Errata

Applies to IP65 step motors from pilot production build

HW23-598-099
 HW23-598D-099
 HW23-601-099
 HW23-601D-099
 HW23-753-099
 HW23-753D-099
 HW23-754-099
 HW23-754D-099
 HW34-506-099
 HW34-506D-099
 HW34-696-099
 HW34-696D-099

Eight lead motor connected in PARALLEL to a bipolar drive.

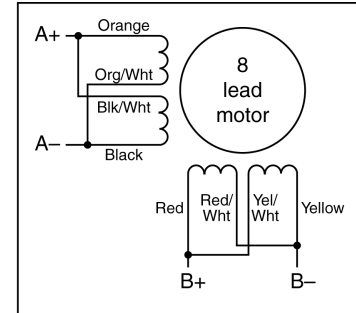
1. Some units have cables that are rated 80°C. These motors should be operated such that the case temperature does not exceed 80°C.
2. The wire colors may differ from our standard. See wiring diagrams below and on the back.

Motors with orange, orange/white, red, red/white, black, black/white, yellow, yellow/white.
